Cleveland National Forest Power Line Replacement Projects

To: Lisa Orsaba, California Public Utilities Commission (CPUC); Allison Rice, Dudek
From: Kirstie Reynolds, San Diego Gas & Electric Company (SDG&E)
Date: May 7, 2020 (Revised May 29, 2020)
Re: Cleveland National Forest Power Line Replacement Projects, Phase II of Circuit 440
Minor Project Refinement Memo

Z:\Projects\SDGE_CNF_ESR\IMXDs\MPRs\MPR48_C440_Ph2\C440_Compare.mxd

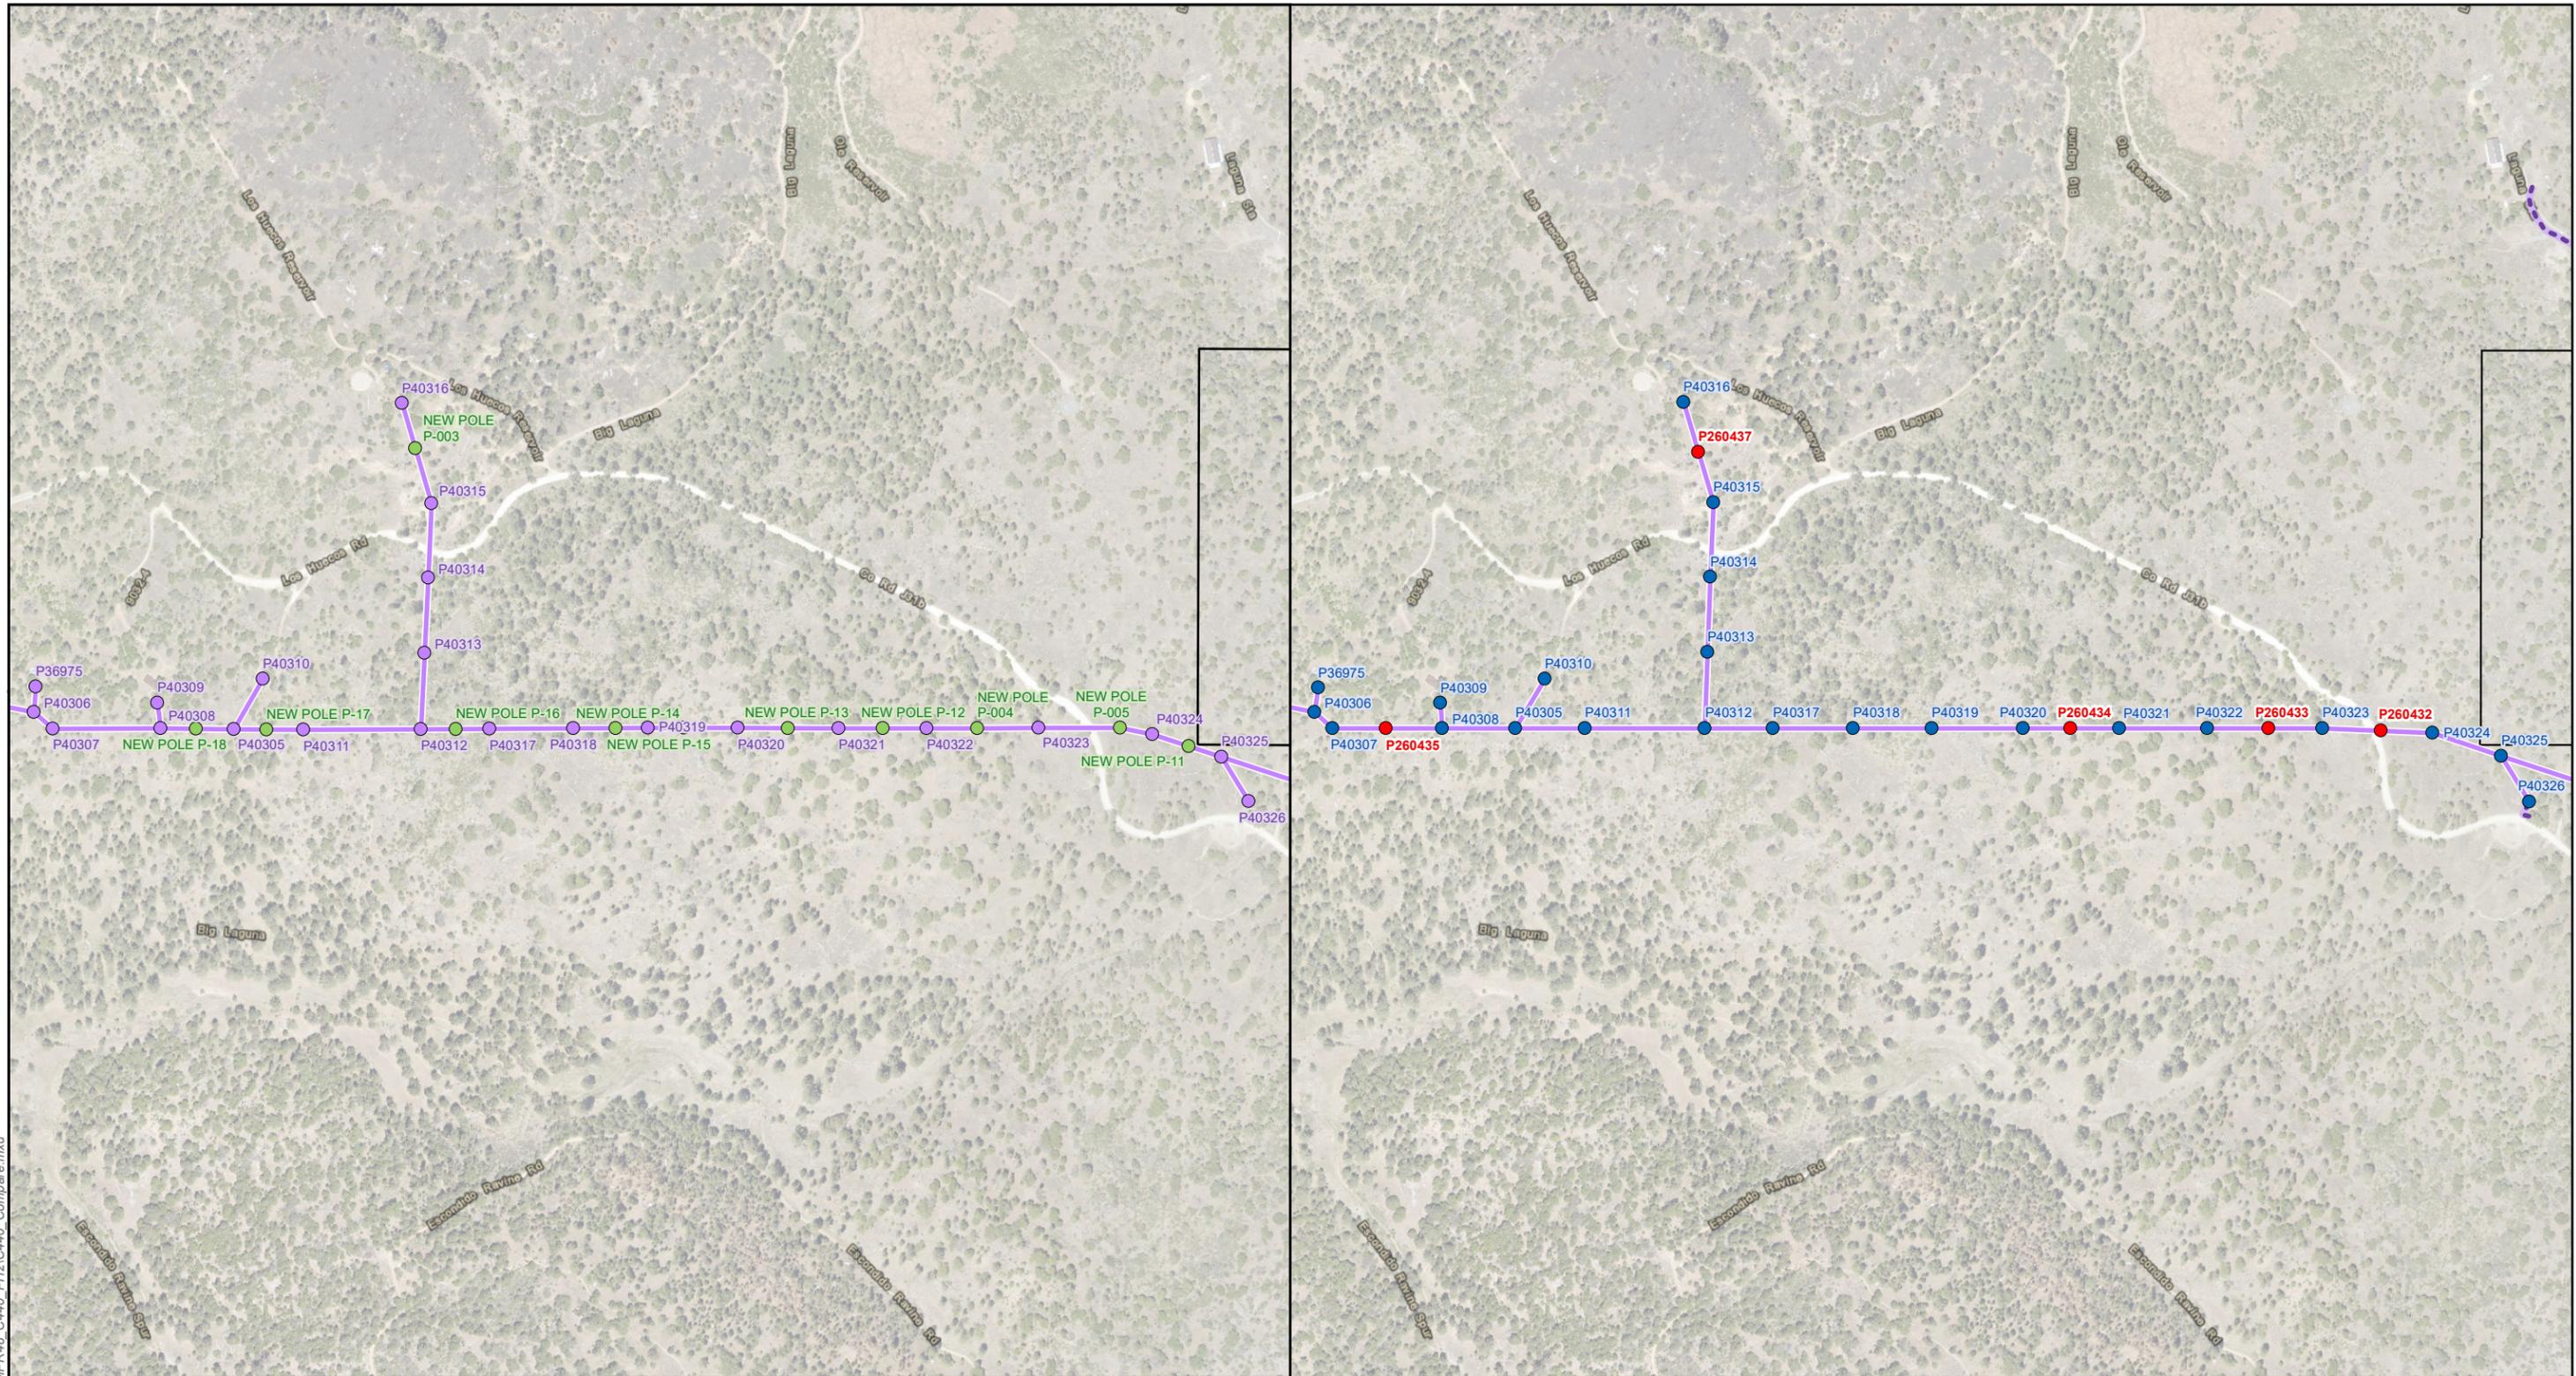
- Undergrounding along Sunrise Highway was stopped north of Mount Laguna Drive due to an ethnographic village site that was identified by the USFS. To reduce impacts to this significant cultural resource site, a portion of the existing overhead line west of Sunrise Highway will be removed and rerouted on the east side of Sunrise Highway as new overhead.

- Due to concerns expressed by the USFS regarding subsurface resources (i.e., hydrology) and the potential to create a dam effect that prevents water flow in the area, the final design includes the overhead rebuild, rather than undergrounding, of the existing overhead parallel to Los Huecos Road.

- Near Little Laguna Lake, to prevent impacts to sensitive biological and cultural resources, the final design includes overhead rebuild rather than undergrounding.

- Due to concerns expressed by the USFS regarding biological resources, vernal pools, subsurface resources (i.e., hydrology), and the potential to create a dam effect that prevents water flow in the area, as well as potential impacts to sensitive cultural resources, the final design includes overhead rebuild instead of undergrounding within the existing road near the Laguna Campground.

A map comparing the Proposed Project to the final design for Phase II of C440 (i.e., NTP request #27) is attached at Attachment C: Phase II of C440 Compare Map. All underground components that were carried forward from the Federal Preferred Alternative are included under a separate header (Federal Preferred Alternative) in the legend for the final design. Table 1: Phase II of C440 Undergrounding Comparison displays the miles of undergrounding that was anticipated for the Proposed Project and Federal Preferred Alternative, and what is included in the final design.
